PAHOKEE HIGH SCHOOL STADIUM AND CONCESSIONS

Issue: Vertical accessibility to all rows of seats.

**REQUEST FOR WAIVER FROM ACCESSIBILITY REQUIREMENTS
OF CHAPTER 553, PART V, FLORIDA STATUTES**

Name: BOCA RATON HIGH SCHOOL, STADIUM BLEACHERS

2 BLEACHER PAVEMENT PLAN - HOME SIDE

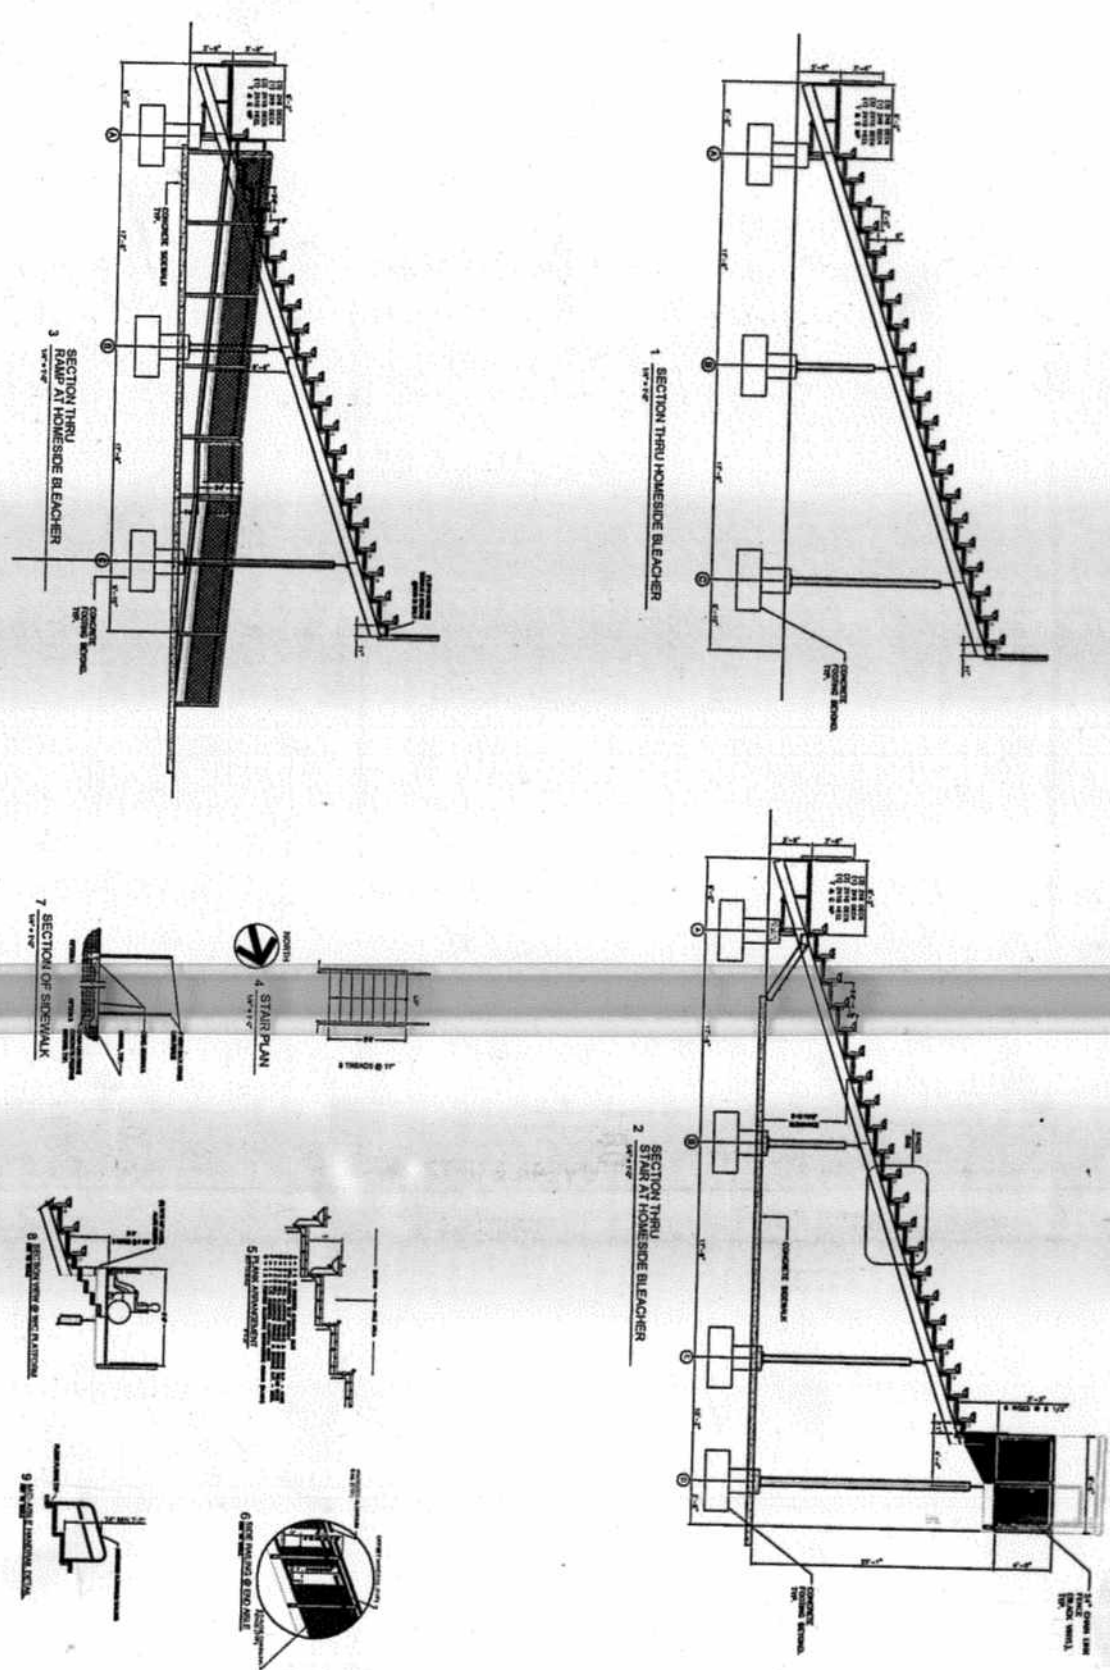
a. This issue is being referred to the Florida Building Commission because the plans do not show accessibility to all levels of the bleachers as required by Florida specific requirements of FBC-Building section 11-4.1.3(5)

THE STADIUM BLEACHER SEATING ARRANGEMENT PROVIDES OPTIMUM SIGHT LINES FOR STUDENTS AT TWO LEVELS. FOUR RAMPS ALLOW ACCESS TO THE LOWER/FRONT LEVEL SEATING WHERE SEATING IS DISPERSED ALONG THE LENGTH OF THE FRONT ROW. AN ELEVATOR PROVIDES ACCESSIBILITY TO THE UPPER/REAR LEVEL AND TO THE PRESS BOX. THE TOP ROW PROVIDES GROUPED ACCESSIBLE SEATING AND ACCESS TO THE PRESS BOX AND ADJACENT FILMING PLATFORM. IN THE PAST THE FILMING PLATFORM HAS TYPICALLY BEEN LOCATED ON TOP OF THE PRESS BOX ROOF ACCESSED BY LADDER; THE PLATFORM IS NOW LOCATED ADJACENT TO AND AT THE SAME LEVEL AS THE PRESS BOX TO PROVIDE ACCESSIBILITY.
